CERTIFICATE OF APPROPRIATENESS

Property: 7947 Rockhill Street, Lot 39, Block 12, Glenbrook Valley Sec 10. The property includes a one-story single-family residence on a 6,500 square foot (70.08' x 123.82') interior lot.

Proposal: Alteration – Windows

FRONT ELEVATION – BEFORE

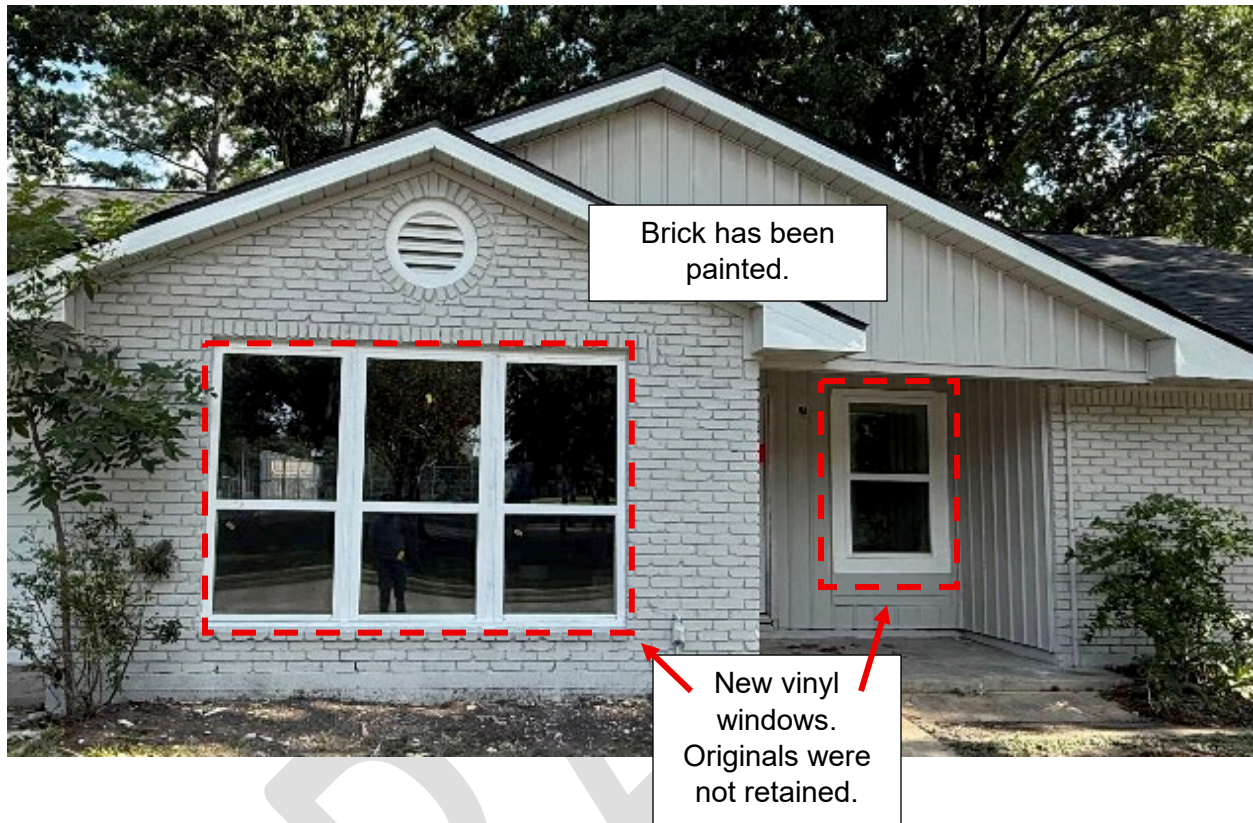
The applicant completed work without a permit for change of four original front elevation windows and for painting on unpainted masonry. The original windows were changed from aluminum to vinyl.

<i>Aluminum windows are a defining architectural feature of the home. Vinyl windows create a later appearance of the structure and violate the 1-1 Window Replacement (HOP) internal policy.</i> |

Original, unpainted
brick.

All four original
aluminum
windows prior
to removal.

Recommendation: Denial - does not satisfy criteria 1, 3, 4, 9, and 10, and issuance of COR requiring removal of paint from brick, removal of replaced vinyl windows, and reversion of inset aluminum windows.

Historic Window Standard: New Construction & Replacement

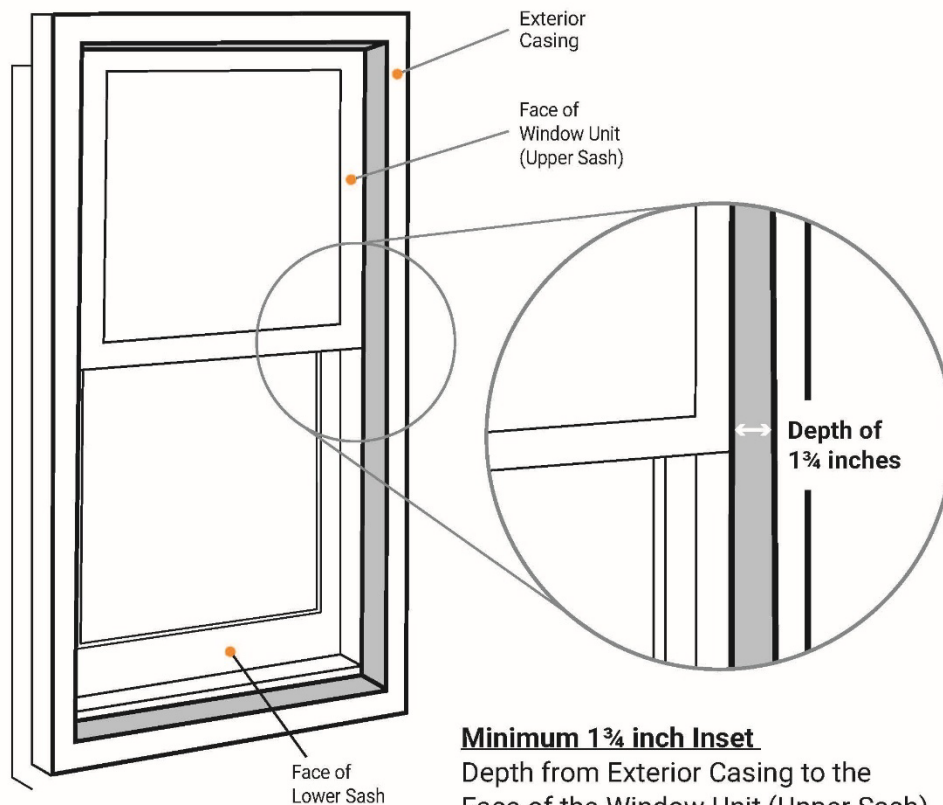
- 311 complaint and building inspector at site, 7/22/2025
 - Unpermitted work for windows and plumbing
 - Red tag issued
 - See Attachment B for Inspector report.
- Windows: Vinyl
- Paint color: BEHR Silver City
- No other work was done to the exterior that is visible from the street.
- **All windows to be inset and recessed. See Attachment A for details.**
 - **Minimum 1¾ inch inset** depth from exterior casing to the face of the window unit (Upper Sash) Windows must be 1-over-1 if single or double-hung and equally horizontally divided. 1 ¾ inch minimum inset for Fixed Window.

Minimum 1 3/4 inch Inset

Windows must be 1-over-1
(equally horizontally divided)

1 3/4 inch minimum inset for Fixed Window
